**SUBJECT:** Savannah River Site's Responses to the Regulatory Comments on the Effectiveness Monitoring Report (EMR) for the C-Area Groundwater (CAGW) Operable Unit (OU) Removal Action (U) - July 2022 through June 2023 (SRNS-RP-2023-00913, Revision 0, October 2023) SEMS Number: 82

**SRS Responses to SCDHEC Comments on the Effectiveness Monitoring Report (EMR) for the C-Area Groundwater (CAGW) Operable Unit (OU) Removal Action (U) – July 2022 through June 2023, SEMS Number: 82, SRNS-RP-2023-00913, Revision 0, October 2023**

**SRS Responses to EPA Comments on the Effectiveness Monitoring Report (EMR) for the  
C-Area Groundwater (CAGW) Operable Unit (OU) Removal Action (U) –  
July 2022 through June 2023, SEMS Number: 82,  
SRNS-RP-2023-00913, Revision 0, October 2023**

Photos of Castor Creek unnamed tributary surface water sample locations CCT 02 and CCT 03.

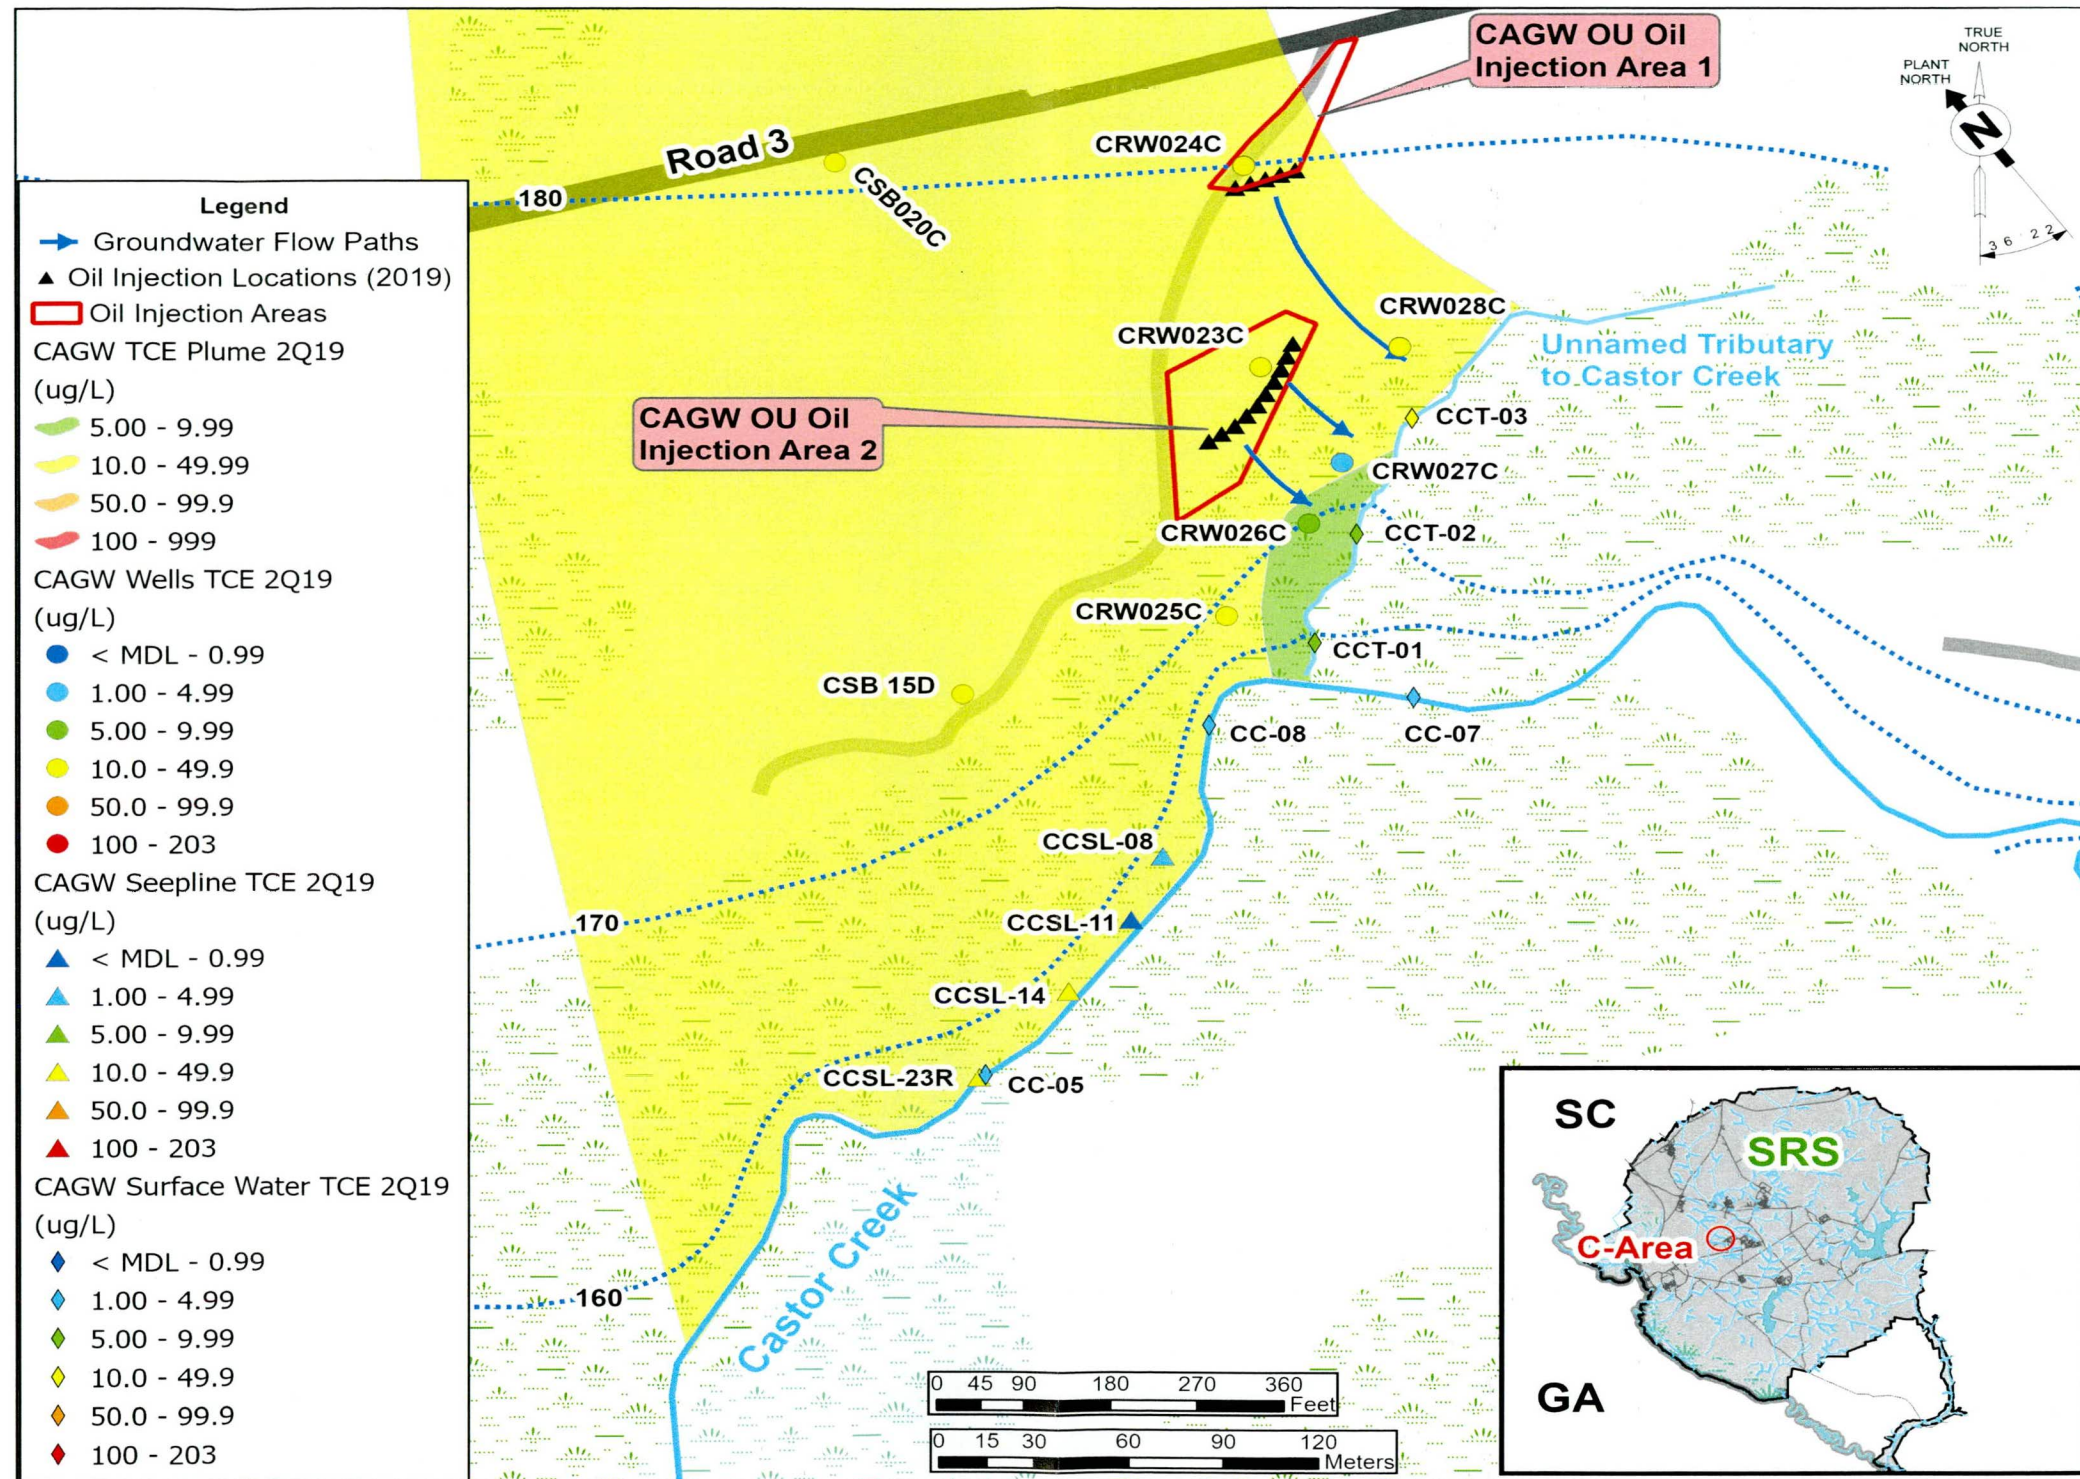
1. It is unclear if the locations where the surface water samples are collected are being impacted by the site conditions (e.g., flow volumes, levels) and therefore may vary at the time of sample collection. For example, surface water stations at the unnamed tributary (i.e., CCT-01, CCT-02, and CCT-03) and Castor Creek (i.e., CC-06, CC-07, CC-08) are shown in different locations. Figure 3 (CAGW OU NTC RA Areas [2019 Baseline Conditions]; Page 36 of 117) shows the locations of CCT-02 and CCT-03 as across the unnamed tributary from monitoring wells CRW026C and CRW028C, respectively; however, Figure 4 (CAGW OU NTC RA Areas [4Q2022]) shows CCT-02 and CCT-03 as located on the same side of the tributary and closer to monitoring wells CRW026C and CRW027C, respectively. Surface water stations CCT-01 and CC-05 exhibit similar inconsistencies in location between Figures 3 and 4. As such, it is unclear if these samples were collected from different locations in the 2019 baseline and current sampling period due to site conditions at the time of surface water sampling. *Please revise the EMR to clarify if these surface water samples were collected at the same locations and if so, ensure the figures are consistent.*

**Samples are collected at the same location where the signs are located (see attached photos of water station sign locations) for each sampling event. There is a defined channel for the unnamed tributary with surface water present, and sampling events are not impacted by site conditions. Figures 3 and 4 (attached) have been revised to correctly show surface water stations CCT-01, CCT-02, and CCT-03 in the unnamed tributary and stations CC-05, CC-07 and CC-08 in Castor Creek. Only stations in the CAGW RA monitoring network are depicted in revised Figures 3 and 4, based on other comments. The surface water stations will be verified to be in the correct locations on all figures in the next EMR report.**

Revised Figure 4. CAGW OU NTC RA Areas (4Q2022)

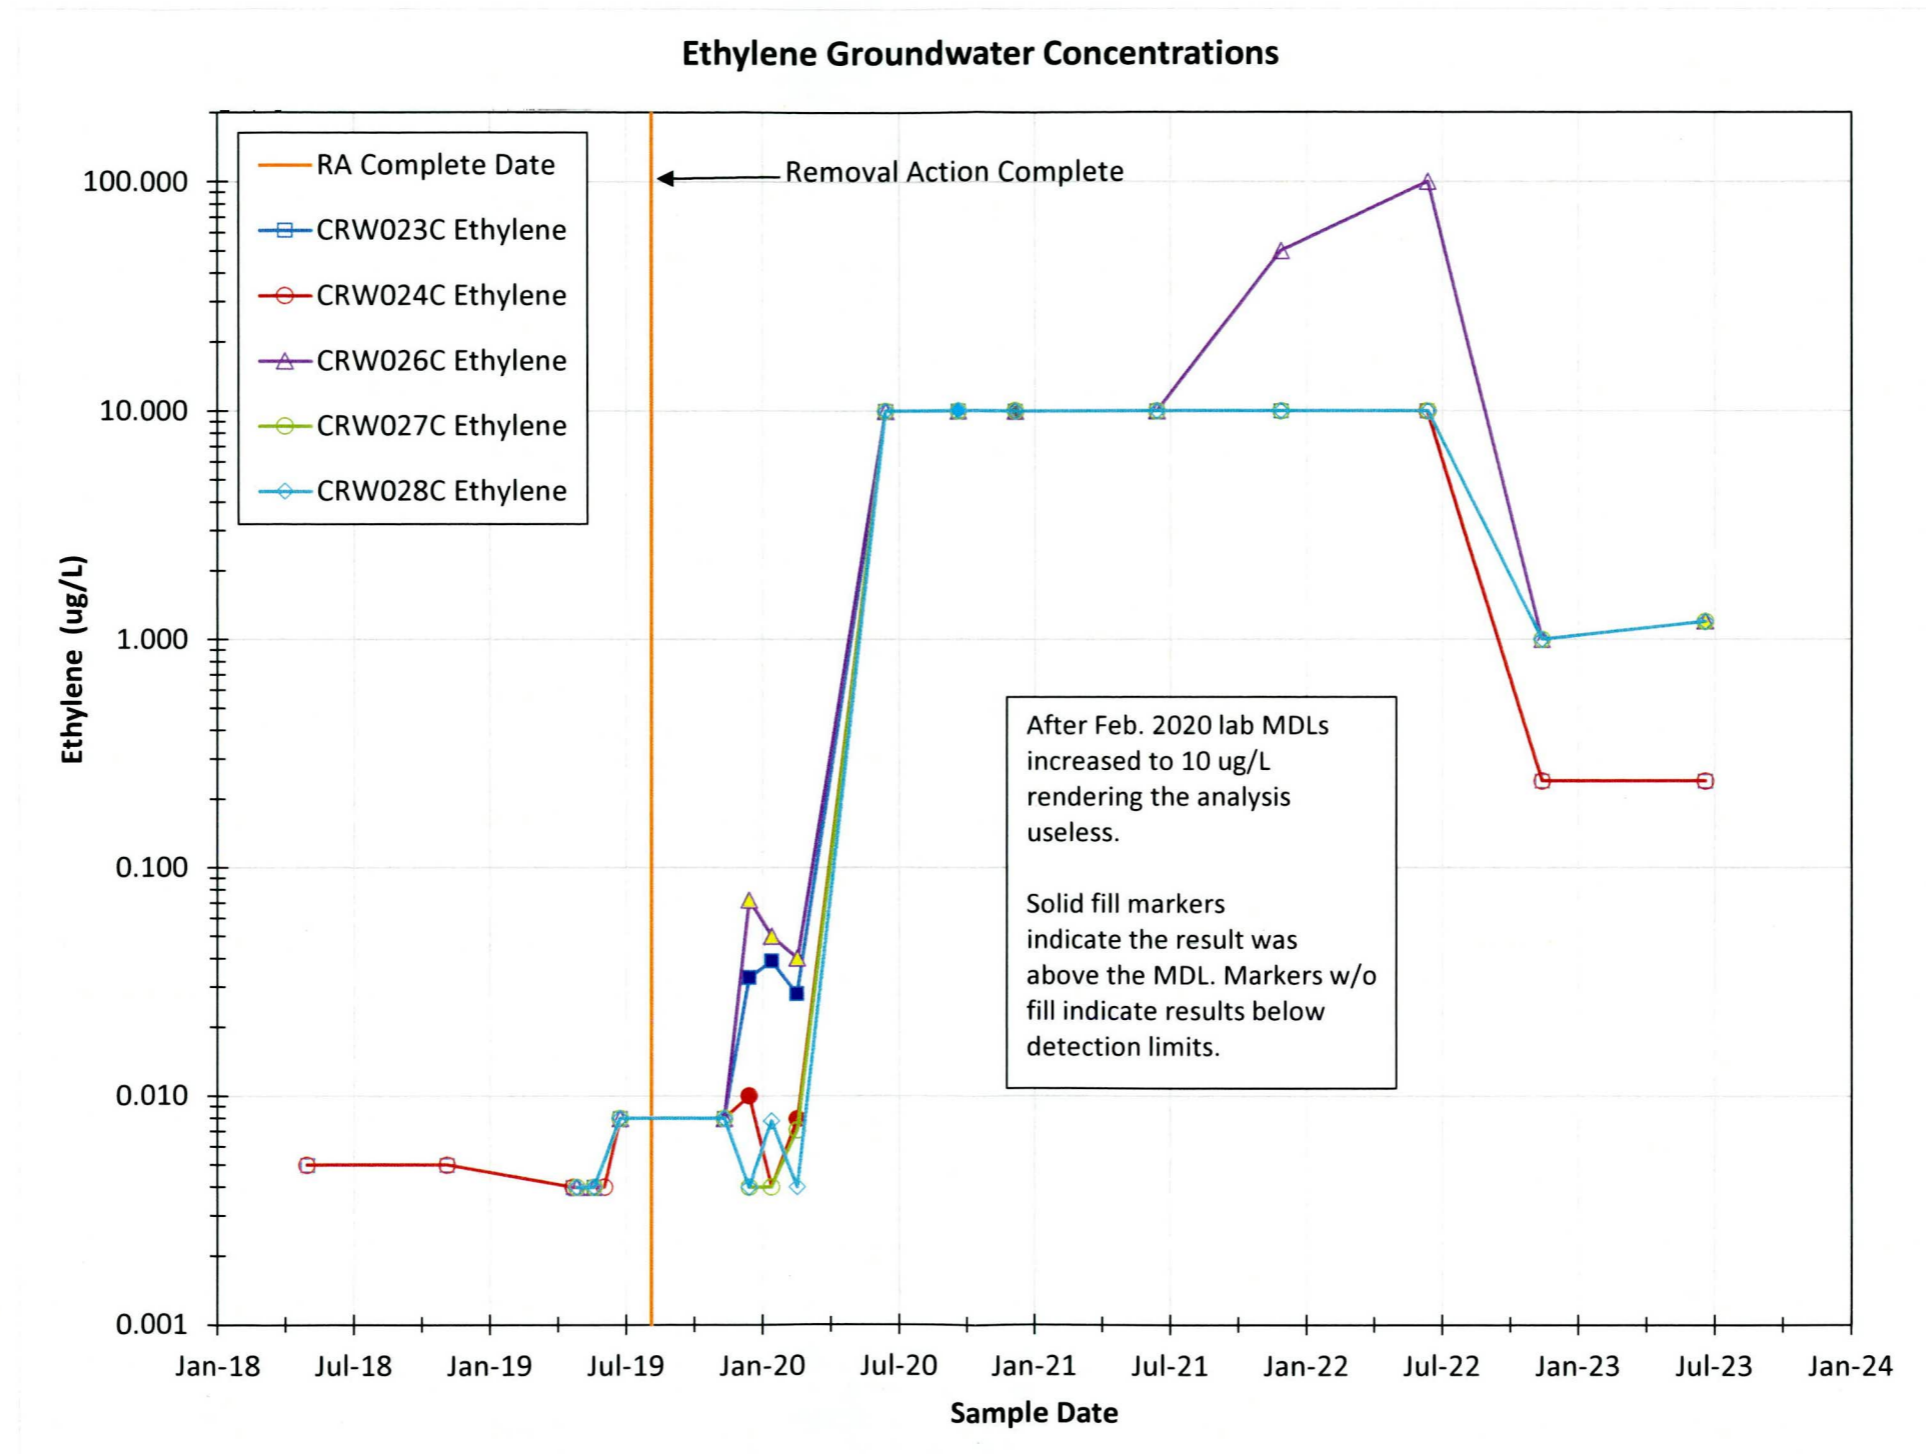
8. Figure 4, CAGW OU NTC RA Area (4Q2022), page 37. Figure 4 depicts CAGW OU NTC RA monitoring station results from 4Q22. CSB020B, CSB020D, CRW 13A, CSB-15B, and CSL001 are not part of the NTC monitoring network, were not sampled in 4Q22, and should not be included in this figure. Furthermore, CSB020B and CSB020D were not sampled during the sampling period detailed in this report although they are identified in Table 4 as CAGW OU monitoring wells that are scheduled to be sampled annually. Please consider revising Figure 4 to only include CAGW OU NTC RA results and discuss why CSB020B and CSB020D were not sampled during this reporting period.

**Figure 4 will be revised in the next EMR to only show stations sampled to support the CAGW NTC RA (Revised Figure 4 attached). Table 4 includes wells that are sampled to support the CAGW NTC RA and wells sampled for the CAGW OU network. In the next CAGW EMR, stations that support the NTC RA stations that support the overall CAGW OU will be depicted in separate tables. Wells CSB020B and CSB020D were sampled in 4Q22 as part of the broader CAGW OU monitoring network (see attached table). No change to the current report is proposed.**

Revised Figure 14 (shown as Figure 16 in the Rev 0 EMR). Ethylene Groundwater Trends

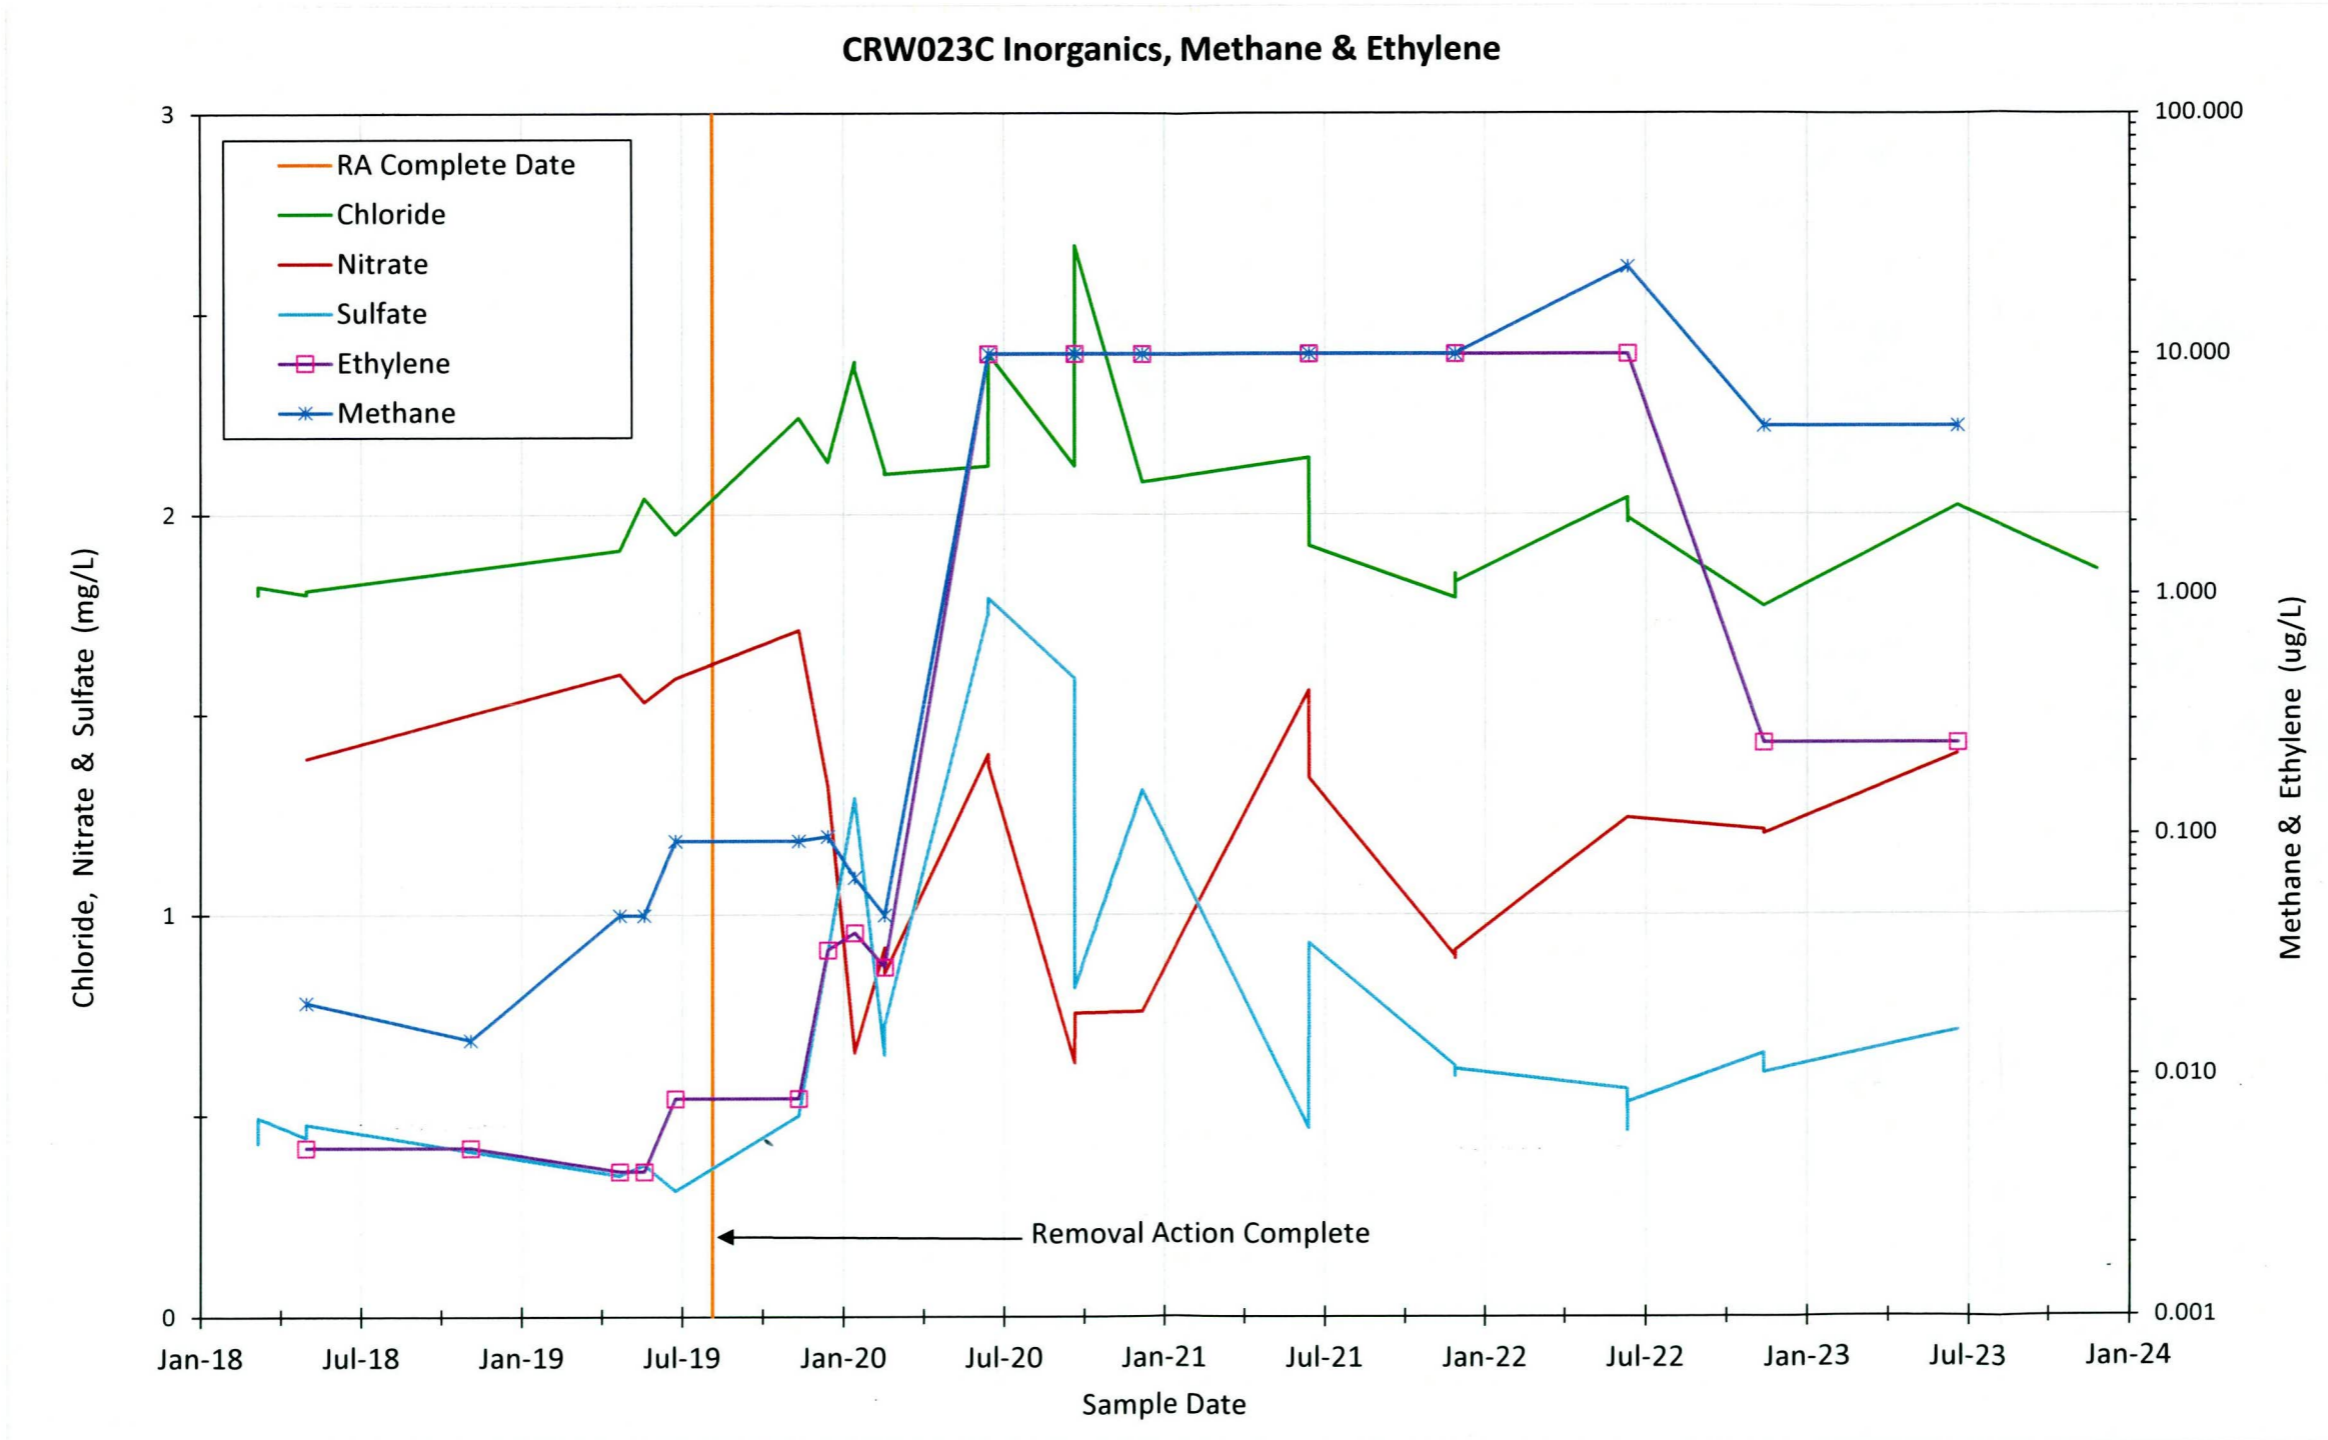
- 3. Figure 16, Ethylene Groundwater Concentrations, Page 50 of 117:** The note on this figure states that elevated method detection limits (MDLs) rendered the analysis of ethylene useless after February 2020, but Section 3.4.1.5 (Ethylene) notes that lower MDLs were achieved in 4Q22 and 2Q23. In addition, it is recommended that the figure show the results that were not detected (ND) differently than the detected data points (e.g., using solid vs. open circles as symbols for each data point) to show the elevated MDLs. For example, ethylene was not detected in 4Q22 but was detected in 2Q23 at several wells. *Please revise Figure 16 to note that the timeframe for the elevated MDLs as discussed in Section 3.4.1.5 and use different symbols for the data points to differentiate between detected and ND results.*

**The revised Figure 14, Ethylene Groundwater Concentrations (shown as Figure 16 in the Rev. 0 EMR), is attached, and a similar chart will appear in the next EMR. No change to the current report is proposed.**
